SEWAGE DISPOSAL SYSTEM

DEPARTMENT OF HEALTH AND MENTAL HYGIENE

LOCATION CERTIFICATION
 #14601 MACCLINTOCK DRIVE; LOT 28, BLK "B"
 SECTION SEVEN, SHT. 3 OF 4 "WARFIELD ESTATES"
 HOWARD Co., MD. Plat Book C.M.P.# 3708

As you are aware, we have applied for and received approval for a pool permit, #98-00114818. The original location of the pool was in the designated septic area, so it was moved out of the area to an accepted location.

True L Pool
 3'-8" Deep

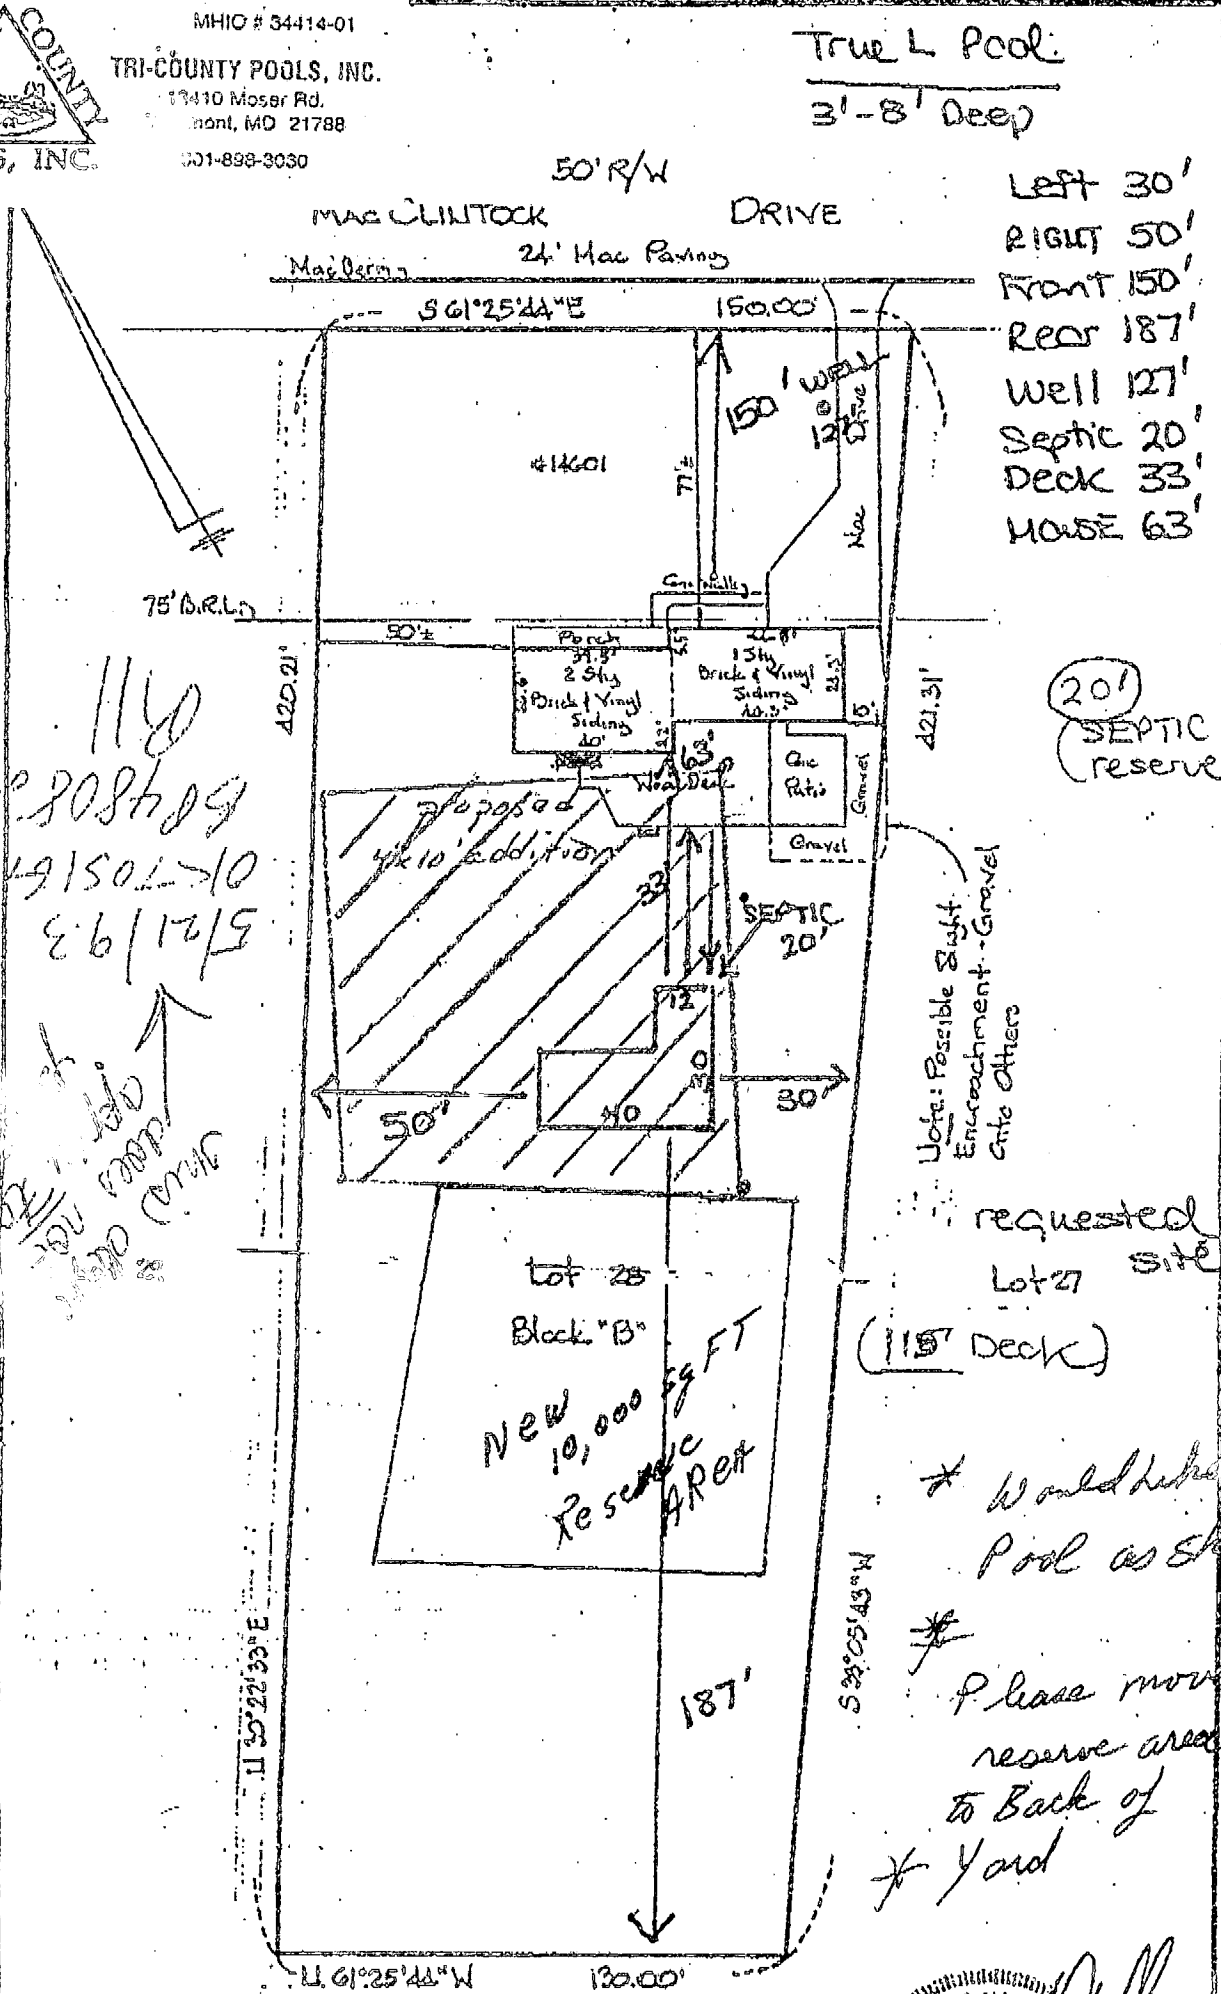
The area of designated septic, in our opinion could not be used due to a very large swale and a backdoor located on the ground level. The homeowner has requested revising the designated area and is willing to pay for the fees necessary. He would like the pool to be located closer to his house and deck as originally indicated. I have enclosed the copies of the approved plat as well as the requested site and designated septic area.

Please review this request, and call us at your earliest convenience for a site inspection with all parties necessary for this site change request.

By copy of this plan,
 the Health Department
 accepts the revised sewage
 disposal area, as indicated.
 Percolation testing was
 conducted in order to
 accommodate a preferred pool site w/in septic
 reserve area.

SOIL PROFILE

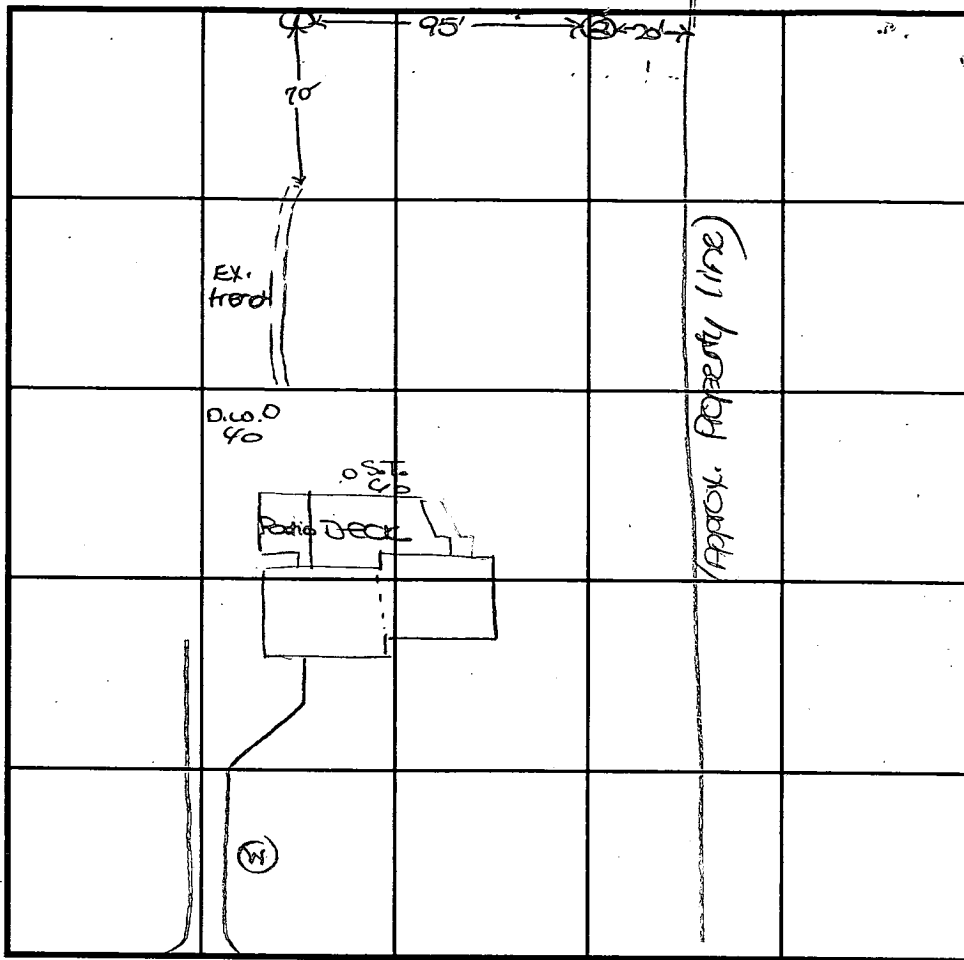
0' topsoil
1' org red brn cl lm
4' pale org tan sa lm
25% hard sh fr
13'

0' topsoil
1' pale org brn cl lm
4' pale org tan sa lm
15-20% hard sh
14'

12/9/98 *
REVISION

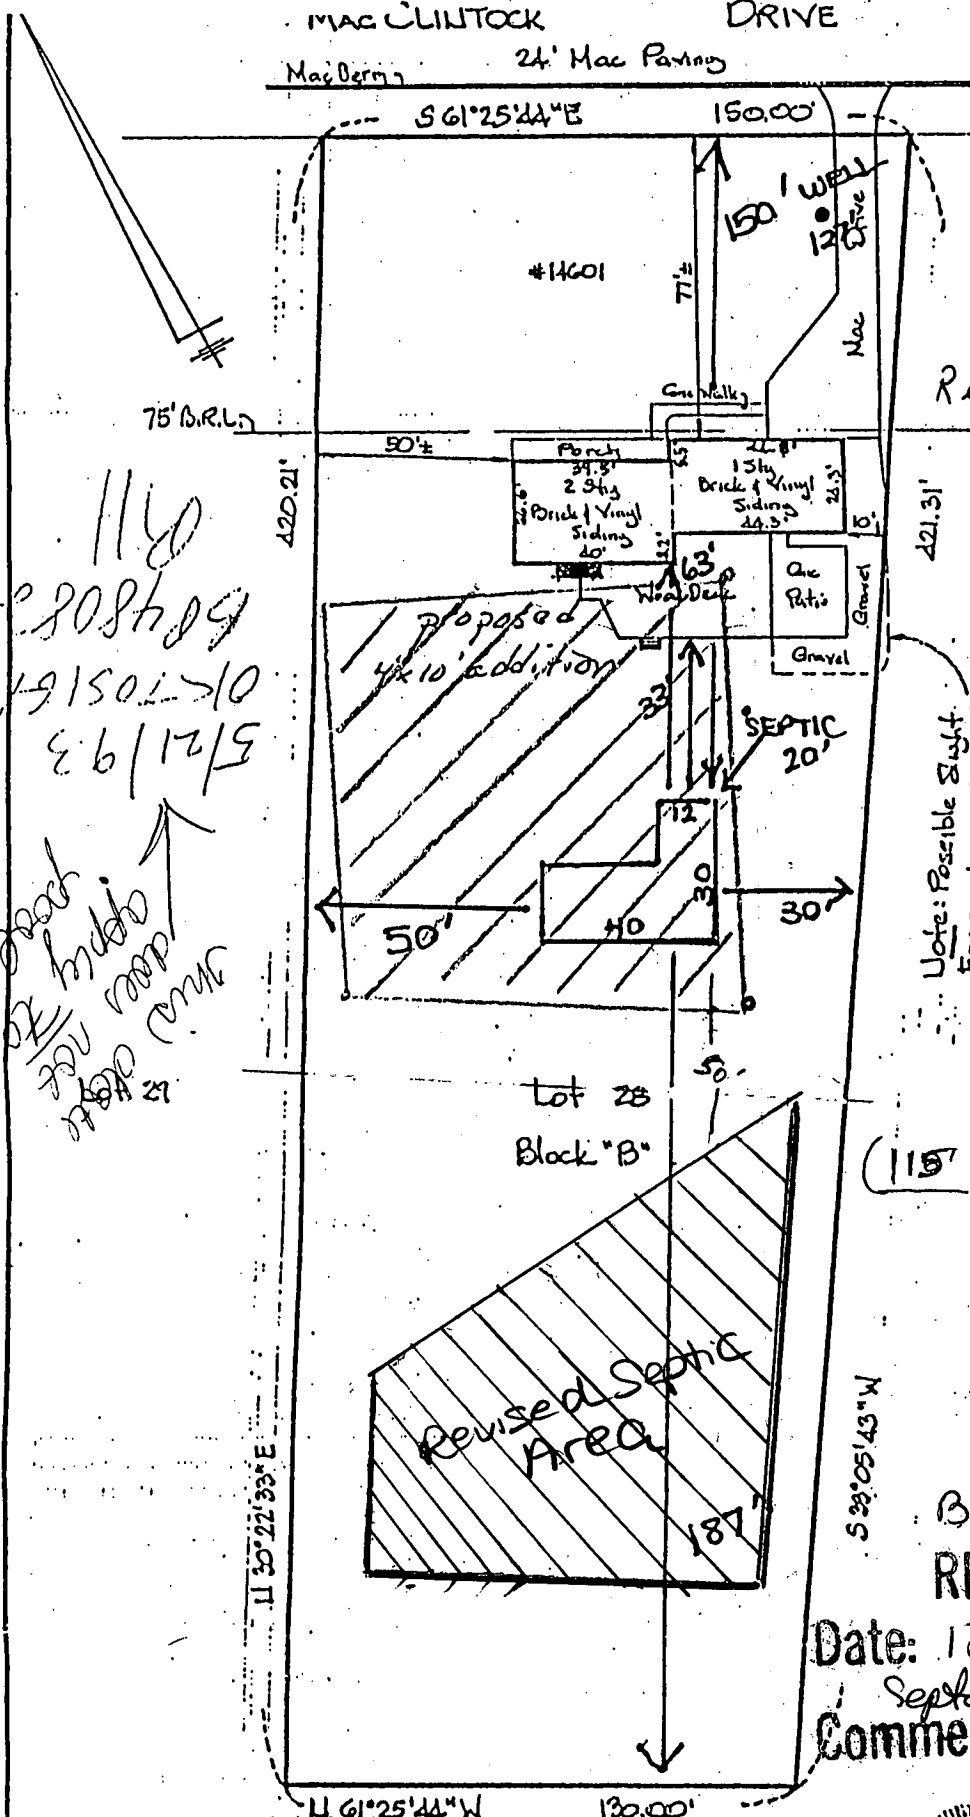
The revision was a change in the septic
area per Kim Sae, approved + changed per
attached drawing / plat plans.

Date: 12/9/98
Septic area relocated per Health
Comments:

Proposed revised
pool location
OK as shown -
original septic
area abandoned
and replaced.
